Access Compliance Report Public Rights-of-Way (Curb Ramps)

Intersection ID: 11672 Main Street: CARTWRIGHT PL Cross Street: KEMPTON PL Location: SW Initial Pass/Fail: Fail **Overall Compliance: No** ADA ID: E9525D17F81B Ramp Type: Perp Severity Score: 21.25

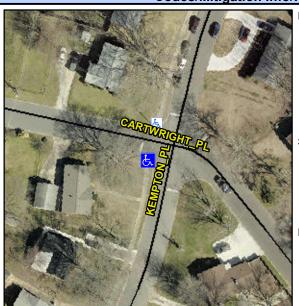
Possible Solutions:	Compliance Description
Remove & Replace Entire Ramp.	N/A Ramp Length (in)
·	No Ramp Width (in)
	N/A Flare Type LT
	N/A Flare Slope LT (%
	N/A Flare Traversable
	N/A Landing Length (in
Surveyor Notes:	N/A Landing Width (in)
N/A	N/A Landing Slope (%
	N/A Landing X Slope (
	N/A Landing Curb? (Y/
	N/A Shared Landing?
PROW/ADA:	N/A Gutter Ponding?
Not Found, R304.5.1, R304.5.3	N/A Gutter Lip Ht (in)
, ,	N/A Painted X Walk1?
	X Walk 1 Direction
	N/A X Walk 1 Width (ir
	X Walk 1 Slope (%
	X Walk 1 X Slope
	N/A Ramp inside XWa
	Road Slope (%)
